## **HEARING REPORT – VOLUME ONE**

### **8 NOTICES OF REQUIREMENTS FOR AUCKLAND COUNCIL AND 1 NOTICE OF REQUIREMENT FOR WAIKATO DISTRICT COUNCIL FOR THE PUKEKOHE TRANSPORT NETWORK**

### **NORs 1,3,4,5,6 & 7 TE TUPU NGĀTAHI – SUPPORTING GROWTH ALLIANCE**

Figure 2: Extract from Drury-Opāheke Structure Plan Drury West Road Network

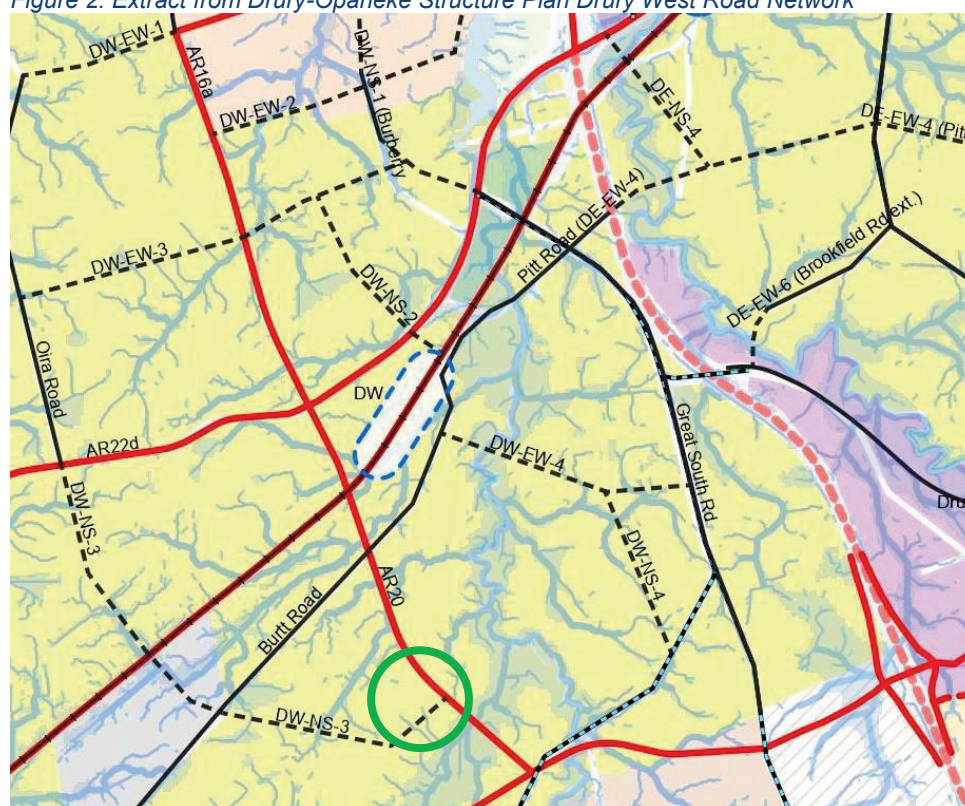
8.118 The DOSP shows the proposed 1:DWA as “AR20” and shows an indicative collector road “SW-NS-3” connecting with the DWA about halfway between Burt Road and the DPL (shown as a green circle in Figure 2).

8.119 The concept design for the 1:DWA does not show this collector road as the exact location is currently unknown. The final form and location of any collector roads will be determined through future rezoning processes (either a Plan Change or a revision of the Unitary Plan).

Figure 7: Extract from General Arrangement drawing Sheet 5

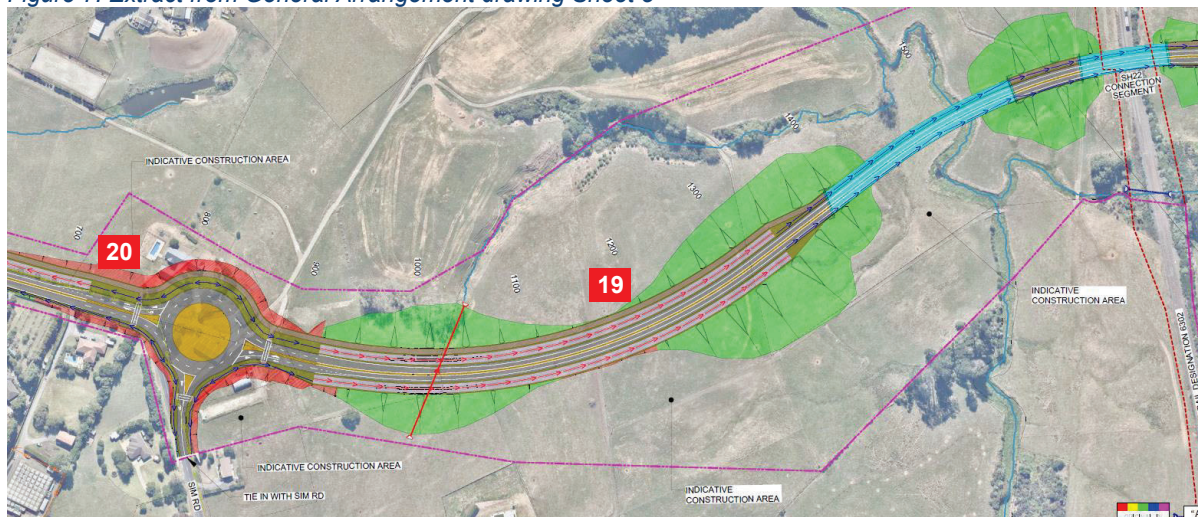
- 11.17 Most alignments propose using the northern part of Sim Road and then pass through farmland to cross the railway and connect with the other parts of the 2:DPL. The absence of the connection across the railway is not considered desirable and an alignment away from Sim Road would presumably involve similar severance of operating farms.
- 11.18 It appears feasible to relocate the roundabout further south away from the buildings to the north of Sim Road, but such a relocation would affect a greater number of other homes.
- 11.19 I consider the assessment of alternatives meets the relevant tests and do not support these submissions.

Figure 8: Extract from General Arrangement drawing Sheet 2

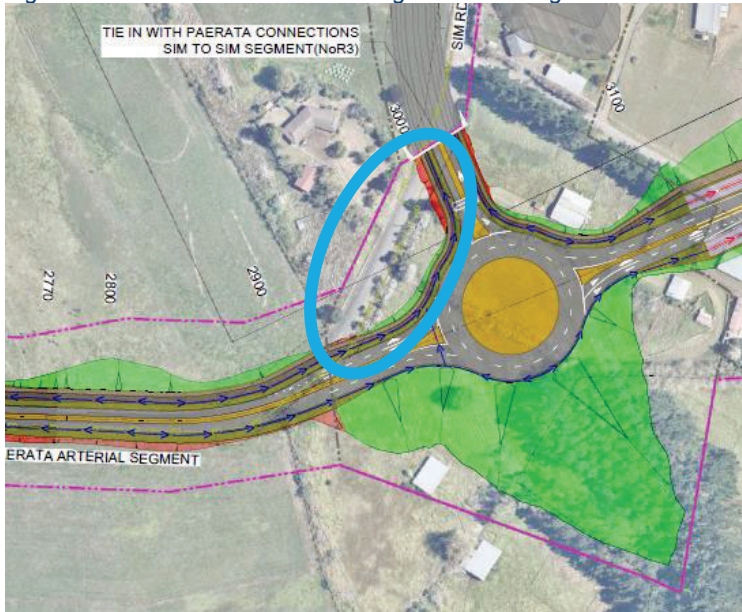
11.22 Using the Sim Road reserve to reconnect both ends of the road would provide an alternate connection between Pukekohe, Paerata and SH22, but would not provide a new connection between Paerata and Drury which is needed to supplement SH22 as increasing the capacity of SH22 is challenging in light of the urbanisation planned to occur along that corridor. Based on the evidence to date I consider the assessment of alternatives is sufficient and do not support these submission points.

Figure 9: Extract from General Arrangement drawing Sheet 1

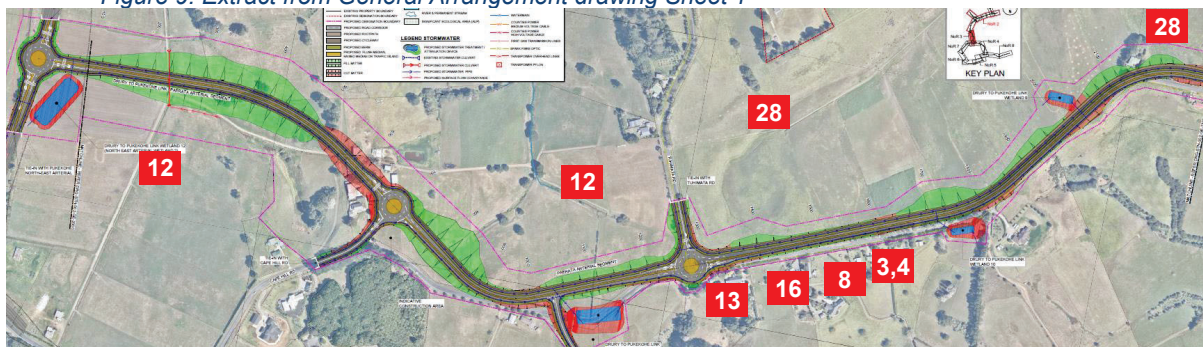
11.24 Submission 12 (McCall G, 229 Cape Hill Road) is concerned the route divides a farm and requests the road be located closer to the railway. This property occupies much of the land west of Cape Hill Road south of Tuhimata Road and north of 4:PNEA.

11.25 Submission 28 (Paerata 5 Farms Ltd, 328 and 412 Sim Road) oppose this segment for the same reasons set out above.

Figure 14: Extract from Pukekohe Road Network<sup>35</sup> with approximate location of submission 3 circled

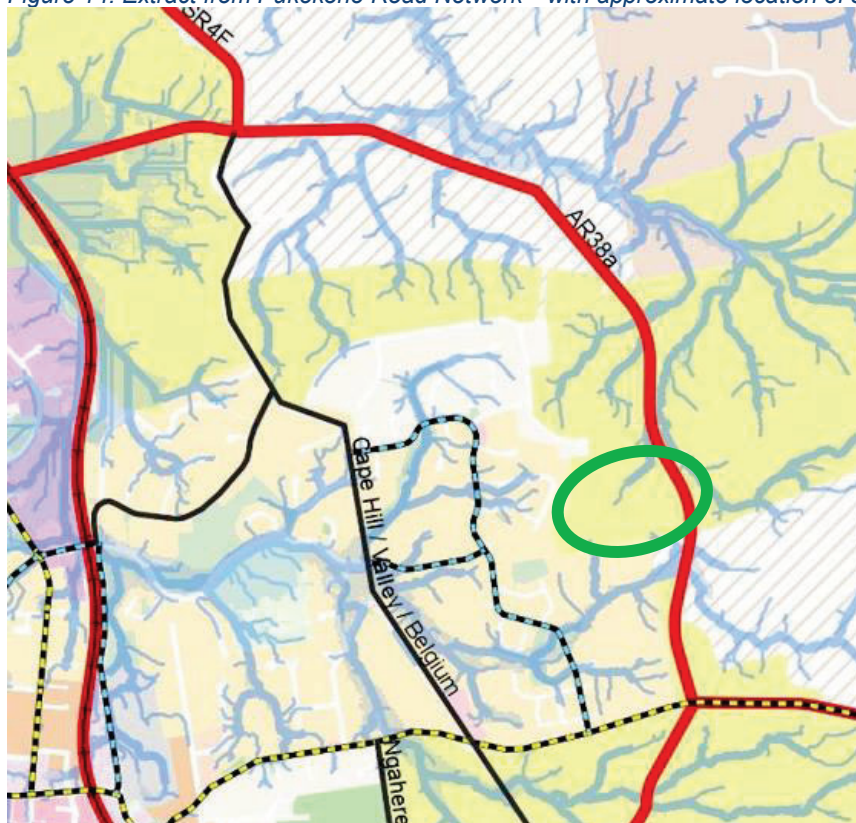
- 11.50 Submission 3 requests at least one road connection is provided to the site described earlier and includes a concept of how the site may be developed. The development concept includes two side roads, one of which is a cul de sac providing access to 16 lots. The two side roads appear to be less than 70m apart.

- 11.51 The ATE explains that the general approach to providing road access to development areas is to have access between the Projects and properties occur via collector roads. I understand the intention with respect to development areas is that the Project would only provide intersections with collector roads. That is consistent with best practice and I expect the collector road network would be broadly similar to that shown in the DOSP and PPSP. The only collector roads shown in the PPSP are existing, with the nearest being Anselmi Ridge Road, Lisle Farm Drive and Twomey Drive to the east.

- 11.52 I do not have sufficient vertical geometry information to determine if the proposed access roads would meet sight distance standards, or if right turn movements at one or both intersections would be feasible. Given the function of the Project and the volume of traffic likely to use the southern intersection I expect it would be undesirable for both intersections to have right turn movements. I expect it would not be possible to confirm the suitability of such access until the Project detailed design and OPW stage.

Figure 18: Gas Pipeline Location [data-firstgas.hub.arcgis.com]

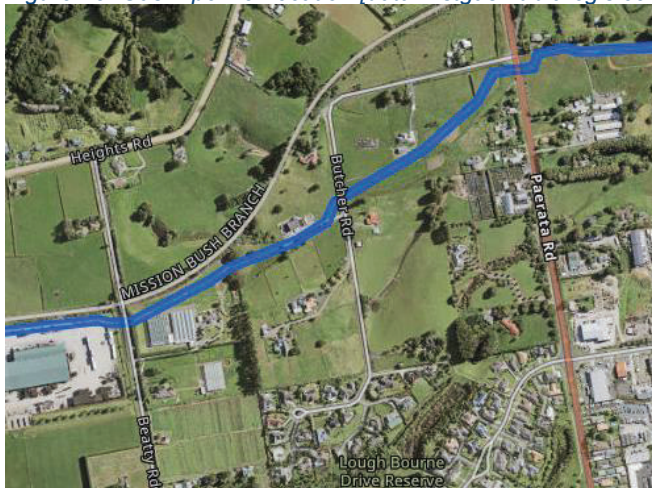
- 11.109 Submission 5 (Morrison D and L, 17, 17A Butcher Road) request the active mode paths be located along the NZ Steel gas pipeline easement. The FirstGas pipeline is shown in Figure 18. There could be multiple issues associated with locating paths on that alignment including

access to the pipeline for maintenance, severance of properties from fencing, lighting of the path, personal security issues and others. I do not support that submission point.
